ALERT SERVICE BULLETIN

205B-21-73

SUBJECT: MAIN ROTOR SCISSORS & SLEEVE HUB

ASSEMBLY COLLECTIVE 204-011-405-013

Figure 1 – Hub Assembly Ink-Stamped Part Number and Serial Number

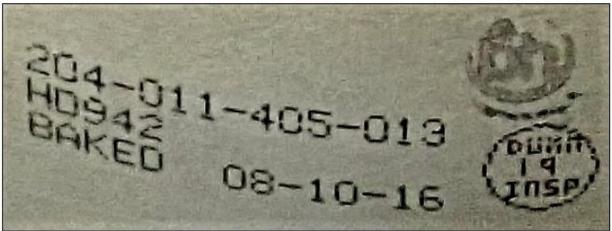
- 3. Gain access to the Hub Assembly 204-011-405-013 and inspect for the presence of part number and serial number matching the Historical Service Record (HSR) at the location shown on Figure 1.
- 4. If the Hub Assembly is not correctly marked, as shown in Figure 1, proceed with **PART II**.
- 5. If the Hub Assembly is correctly marked, as shown in Figure 2, make an entry in the helicopter logbook and historical service records indicating findings and compliance with **Part I** of this Alert Service Bulletin.
- 6. If **Part II** of this ASB is not going to be accomplished immediately, make an entry in the helicopter logbook and historical service records indicating compliance with **Part I** of this Alert Service Bulletin with an annotation to accomplish **Part II** within the required compliance time stated in this ASB.

Maximum depth of vibro-etching or dot-peening shall not exceed 0.005-inch (.127 mm). Part and serial numbers shall be marked in the scalloped area of the hub as shown in Figure 2 of this ASB; to a minimum height of 0.062-inch (1.57 mm) and no closer than 0.100-inch (2.54 mm) to any edge.

- 2. If the Hub Assembly has an ink-stamped part and serial number matching the HSR (refer to example shown in Figure 1), permanently mark the part and serial number on the Hub Assembly by vibro-etching or dot-peening (Figure 2).
- 3. If the Hub Assembly does not have a part number and serial number, create a unique serial number for each Hub Assembly. Using one or two prefix letters consistent with the company name of the operator or repair facility accompanied by a dash and 4 or 5 digits is considered as an industry serial number marking standard. Vibro-etch or dot-peen the Hub Assy with the part number and the assigned serial number (Figure 2).
